DESIGN & ACCESS STATEMENT

WOOTTON PLACE

Wootton
Woodstock
OX20 1EA

This Design & Access Statement has been prepared to accompany a variation of conditions planning application & an application for listed building consent to West Oxfordshire District Council for the proposed changes to the approved development at Wootton Place. It is to be considered an addendum to the original Design & Access Statement which was produced by MBA in December 2021. The changes as outlined in this statement are in our view very much in keeping with the original consent.

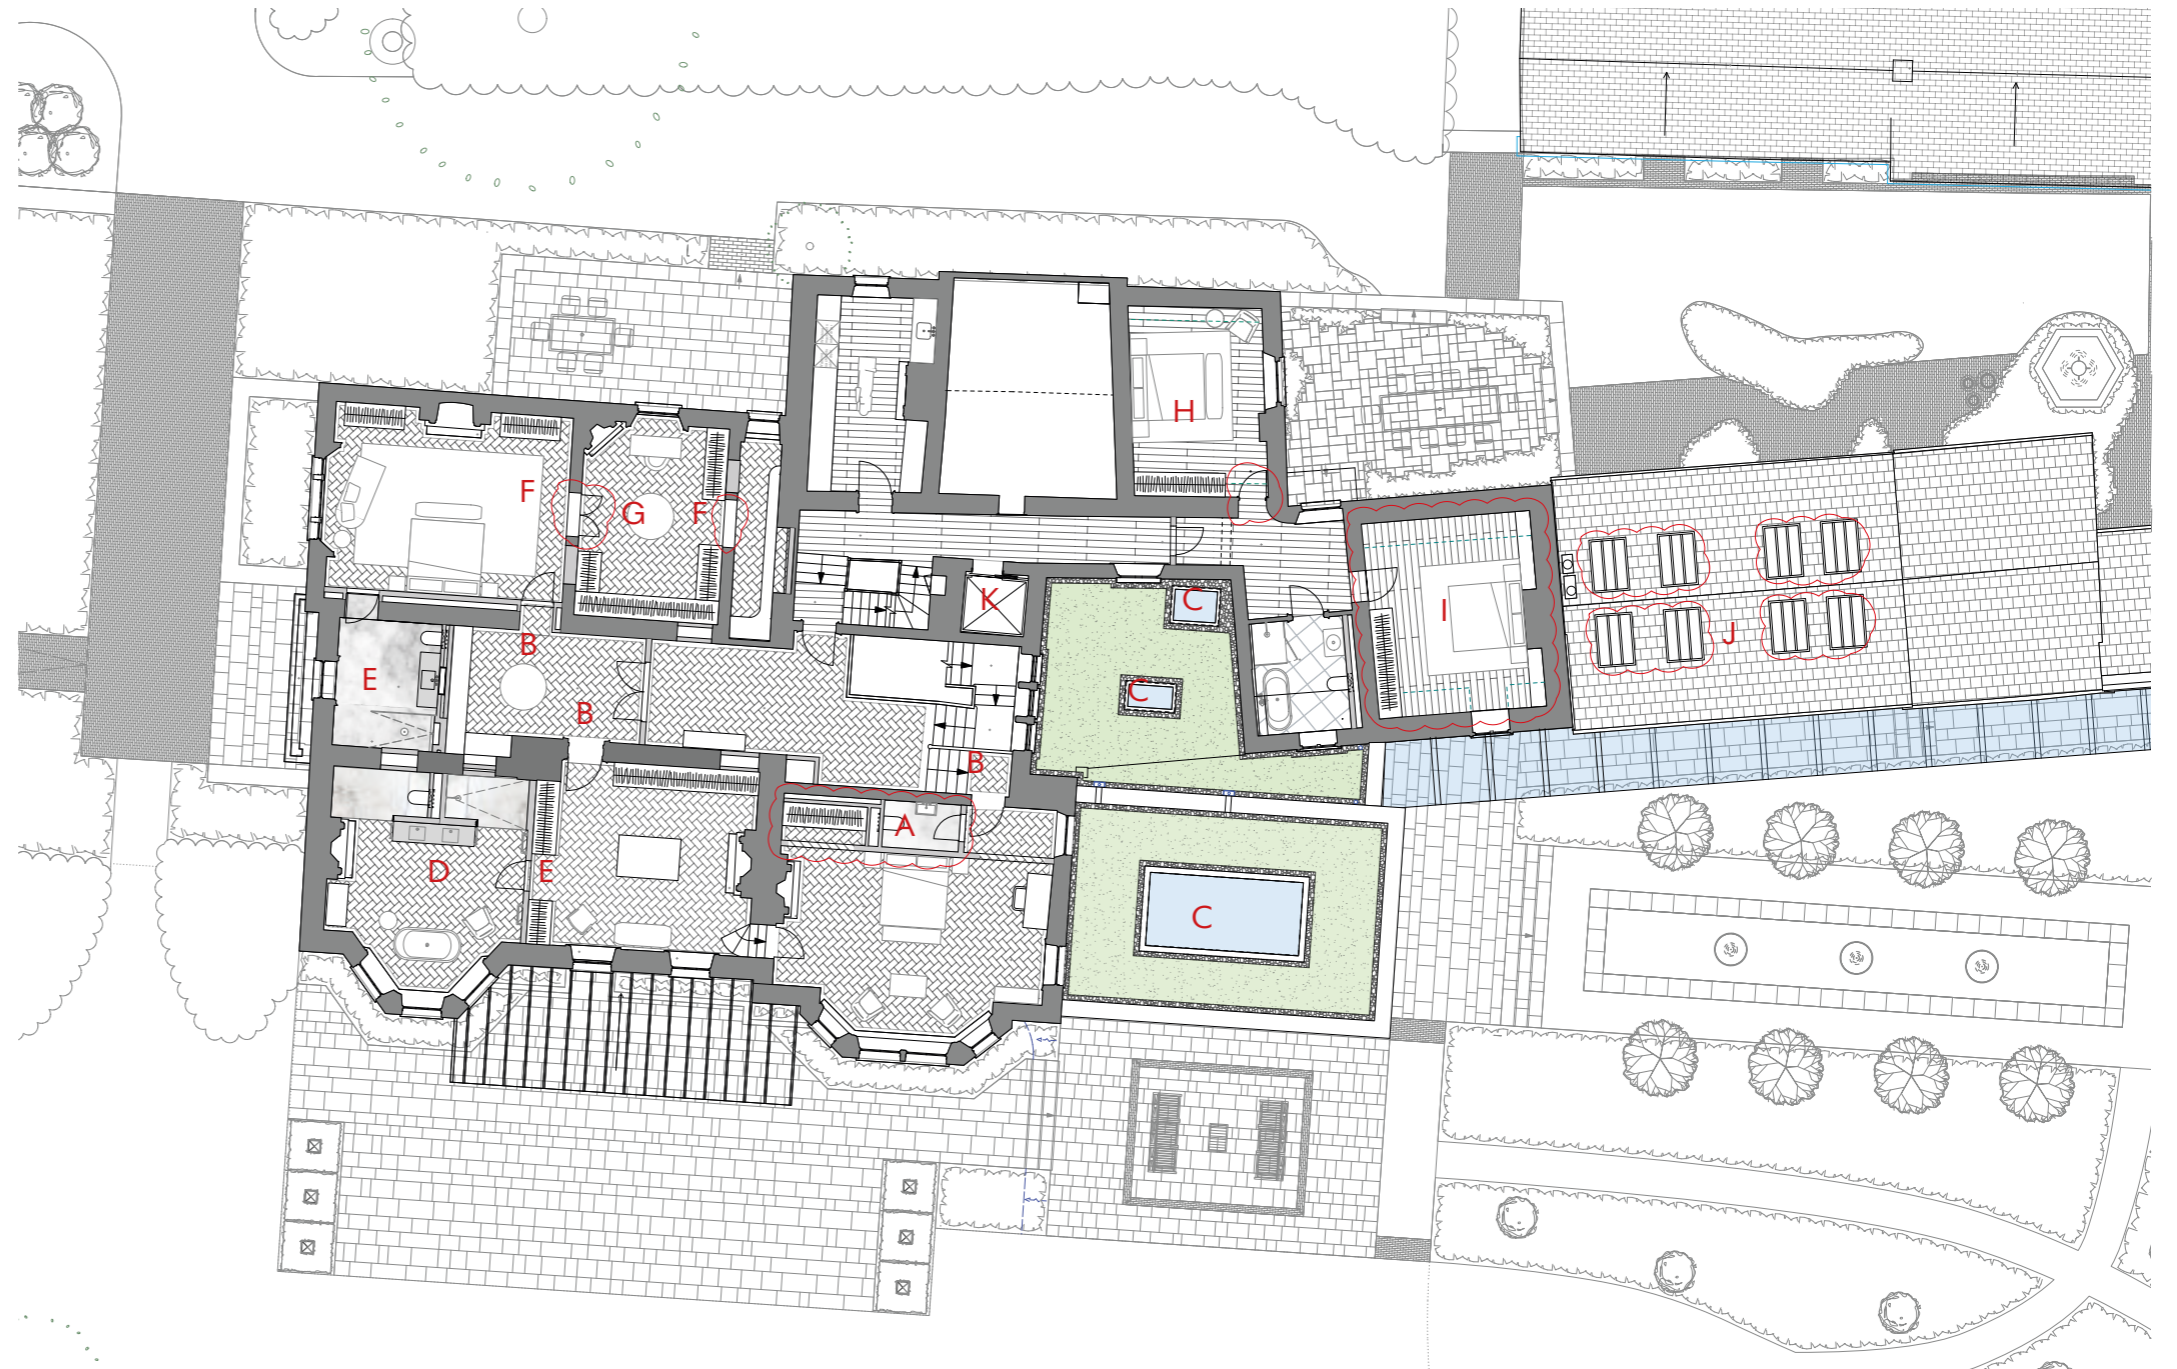
A: New WC in Master Suite

B: Existing openings retained

C: Minor repositioning of rooflights.

D: New ensuite

E: New partition

F: New opening in wall

G: Existing bedroom and en-suite omitted and new dressing area created

H: Existing floor raised to be flush with hallway

I: Historic floor reinstated to create additional bedroom

J: Existing roof replaced and new conservation style rooflights inserted

K: Lift shaft reinstated

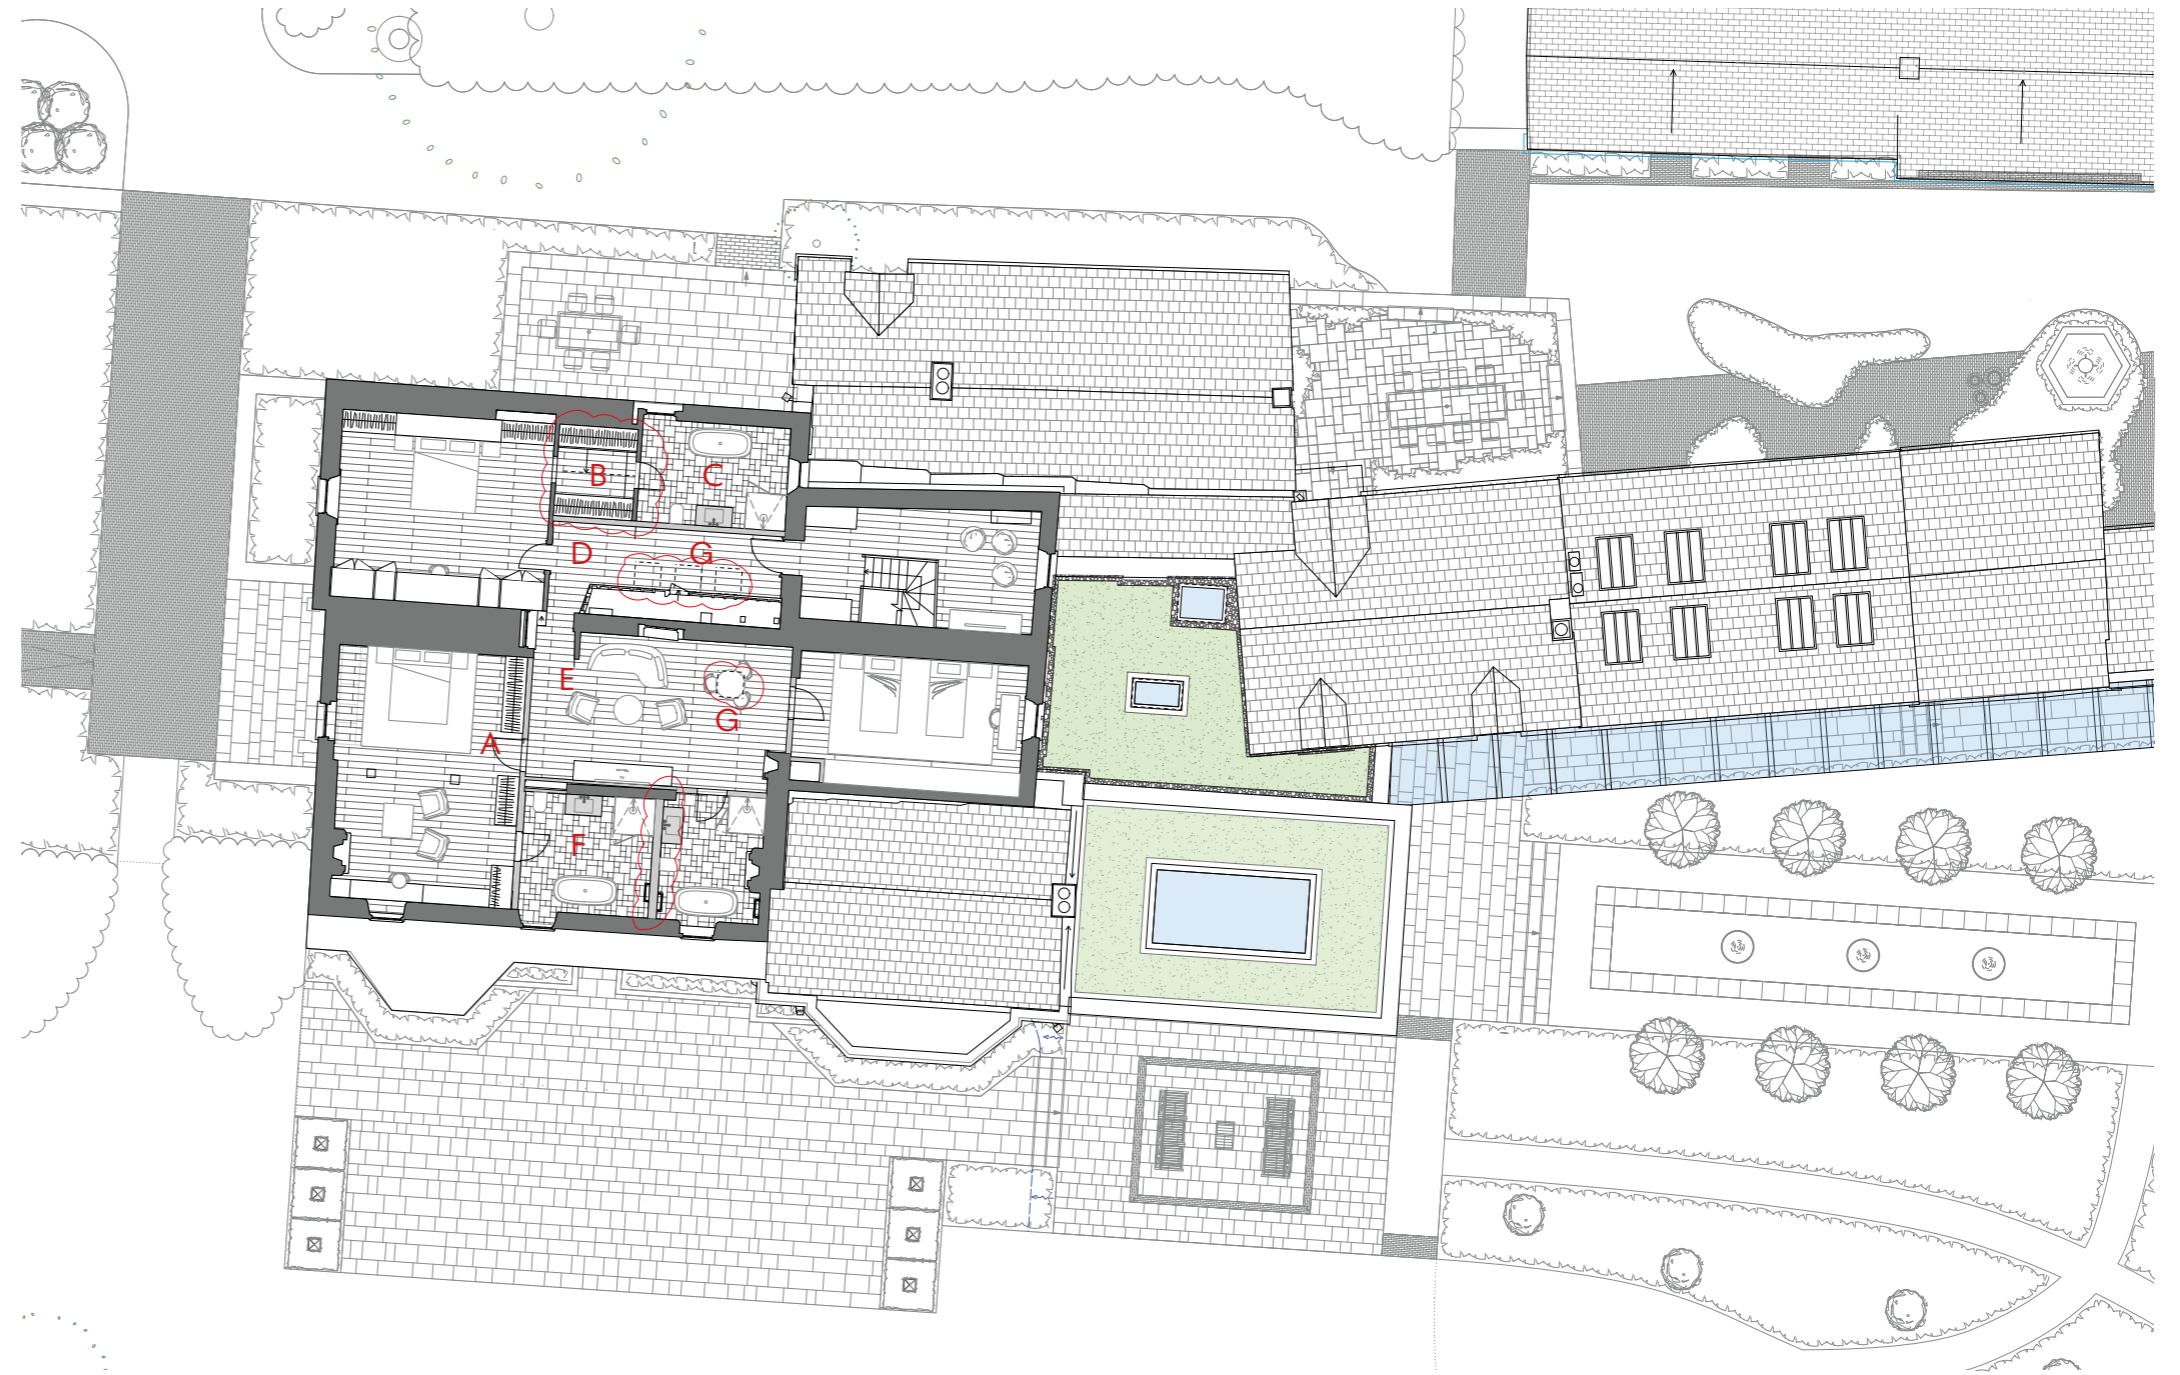
- A: Door to bedroom to be relocated
- B: Existing bathroom reconfigured to dressing room
- C: New en-suite
- D: New hallway
- E: Partition to bedroom removed
- F: En-suite made larger
- G: Conservation style rooflights inserted into sloping roof
